Ref: 7943

September 26, 2018

Re: Supplemental Traffic Engineering Peer Review  
Goodridge Brook Estates – Sterling Road  
Lancaster, Massachusetts

**Figure 8B-6. Example of Placement of Warning Signs and Pavement Markings at Grade Crossings**

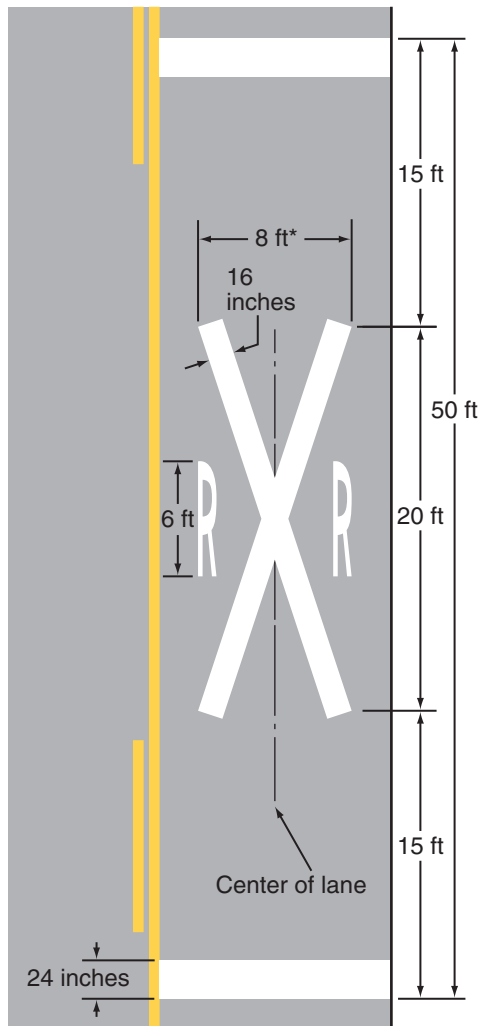
**Response:** The Applicant has committed to installing STOP lines and "STOP Here When Flashing" (R8-10) signs on both Sterling Road approaches to the at-grade railroad crossing in order to enhance safety at the crossing. **In addition, we would recommend that an at-grade crossing warning sign (W10-1) be installed on Sterling Road east of the crossing and**

that the requisite pavement markings for an at-grade railroad crossing be installed on both approaches to the crossing pursuant to the requirements of the *Manual on Uniform Traffic Control Devices (MUTCD)*<sup>1</sup> and illustrated on Figures 8B-6 and 8B-7 (attached). These improvements should be a condition of any approvals that may be granted for the Project. No further response required.
